NOTICE TO ALL FIRMS

Date: April 1, 2022
To: All Prospective Bidders
From: Walter Winter
Director for Procurement Services
Re: Addendum Number 2
IFB C1540 – Goodman Turnstiles

PROJECT:
 SHIRLEY GOODMAN RESOURCE CENTER
 TURNSTILE INSTALLATION
 282 7th AVENUE,
 NEW YORK, NY 10001

1 CELLAR R.C.P. PLAN
SCALE: 1/4" = 1'-0"

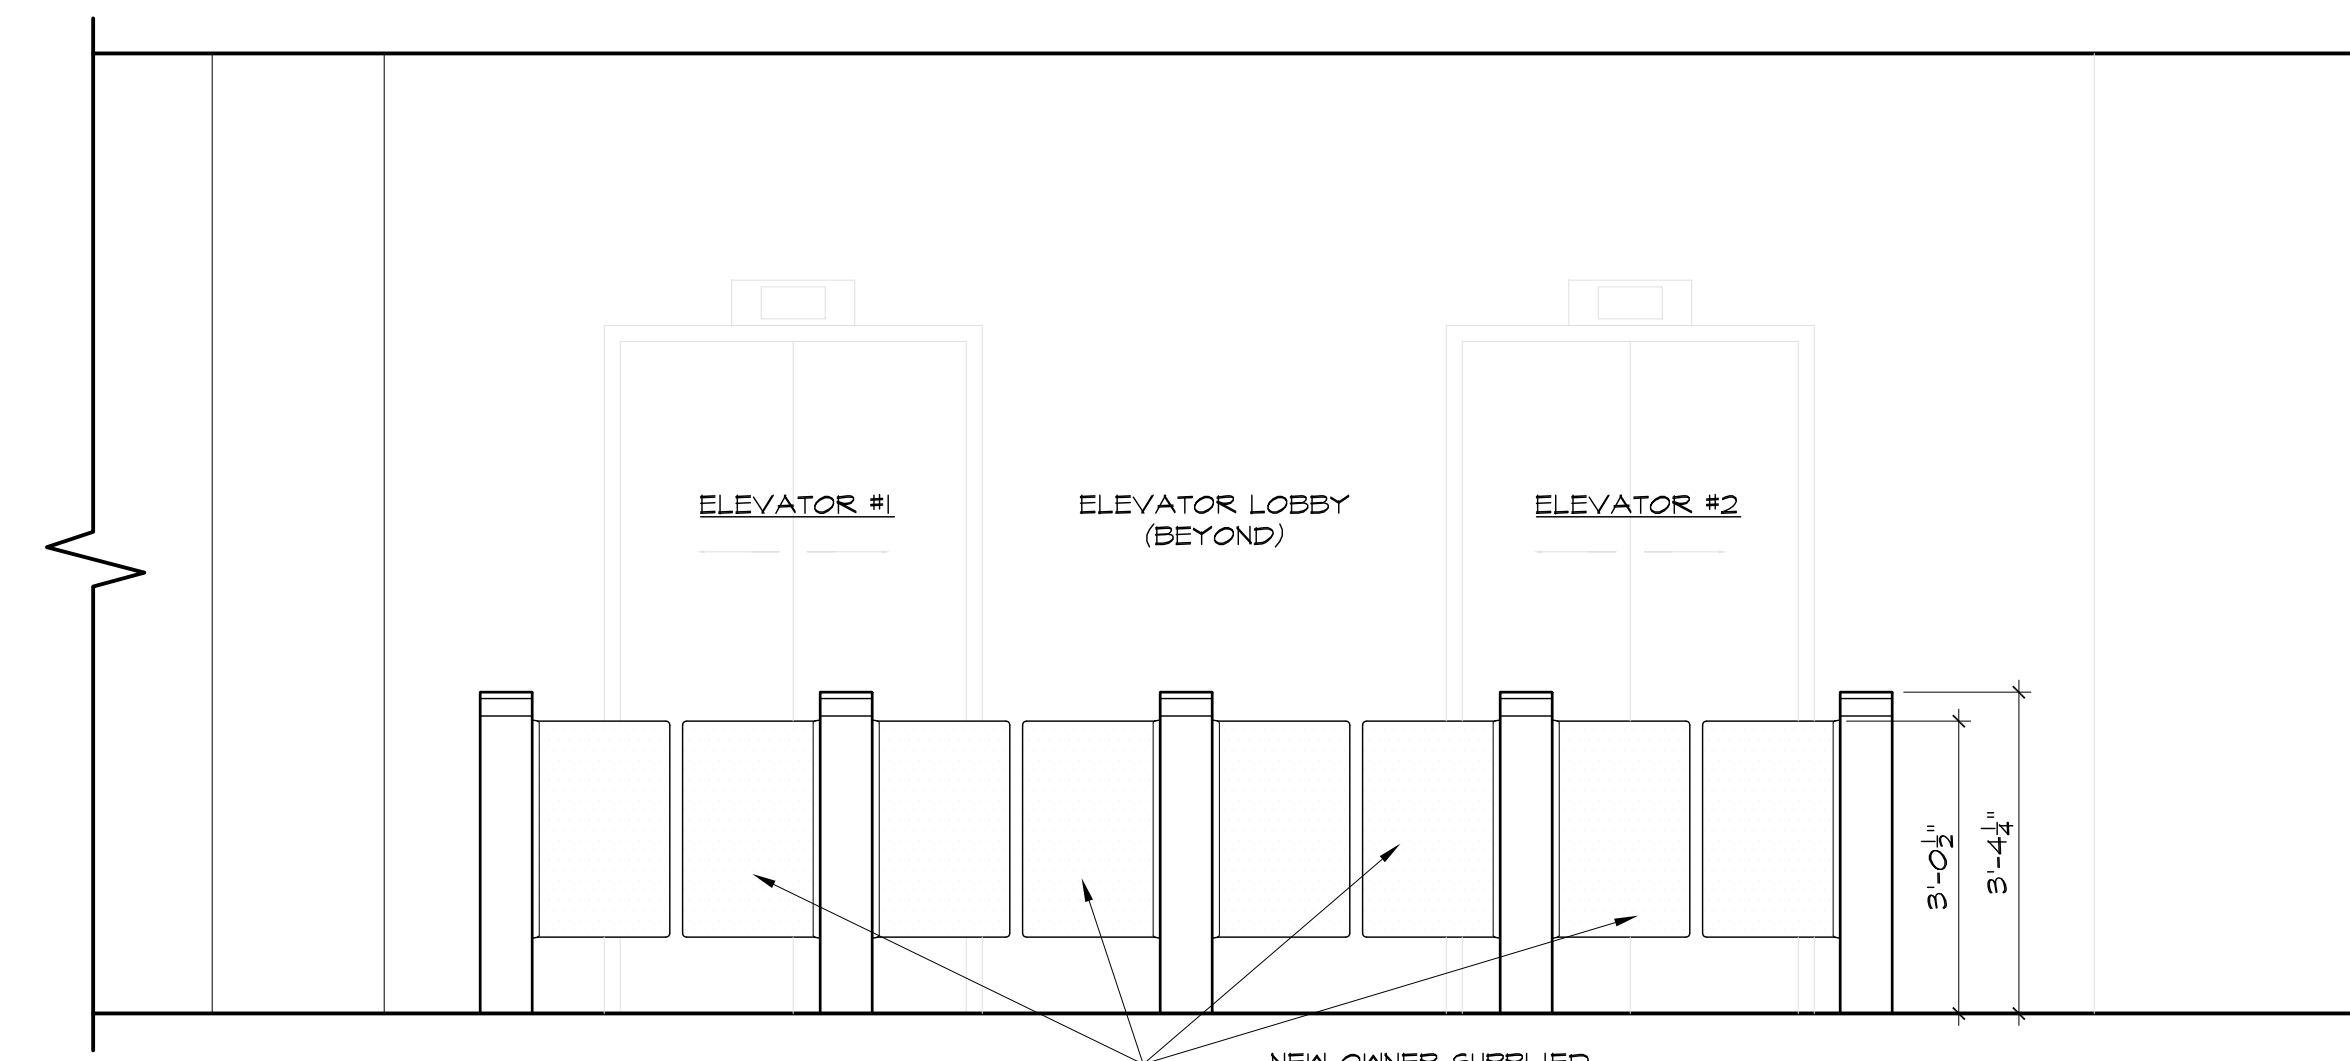
1. Phasing Plan G-002 is being added to the set. The phasing plan indicates the location of temporary barriers and other phasing requirements.
2. Dust and silica mitigation requirements have also been added to the Section III. Contract Terms and Conditions, Sub-Section III. Demolition Notes, item 14., G-002 1st Floor Phasing Plan, A-101 Cellar RCP.
3. Revised documents are attached.

- CONSTRUCTION NOTES**
- 1 CLOSE & PATCH GMB CEILING AS REQUIRED AFTER NEW TURNSTILE INSTALLATION IS COMPLETED.
 - 2 NEW TURNSTILES ABOVE.
 - 3 PAINT CEILING TO MATCH EXISTING.
 - 4 REINSTALL EXISTING TRACK LIGHTING, LIGHT FIXTURES & DIFFUSERS AS REACQUIRED TO COMPLETE THE WORK ABOVE. SAVE FOR RE-INSTALLATION.
 - 5 EXISTING PLYWOOD WALL TO REMAIN. CONTRACTOR TO PROVIDE ALL DUST PROTECTION AS REQUIRED.
 - 6 POLY DUST PROTECTION BARRIER WITH ZIP OPENINGS AS REQUIRED. DUST CONTROL WITH EQUIPMENT WITH BUILT-IN DUST COLLECTION (SUCH AS HEPA VACUUMS) SHALL BE UTILIZED.
